TECHNICAL SERVICE BULLETIN

February, 1975

DIRECTION INDICATOR/WINDSCREEN WIPER SWITCHES MARINA

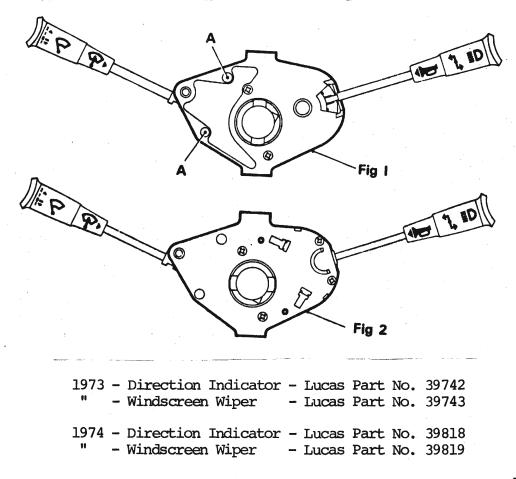
Switches of alternative manufacture are now being fitted to these vehicles.

Whilst the individual wiper or direction indicator switches of the original assembly, Fig. 1, are serviced separately, this is not the case as far as the alternative switch, Fig. 2, is concerned.

Should it be necessary to replace a switch of the latter category, this can only be done by obtaining the two individual switches included in the assembly shown in Fig. 1.

Please note the switch, Fig. 1, is dismantled by removing the two rivets 'A' and reassembled using the two screws supplied with the replacement switches.
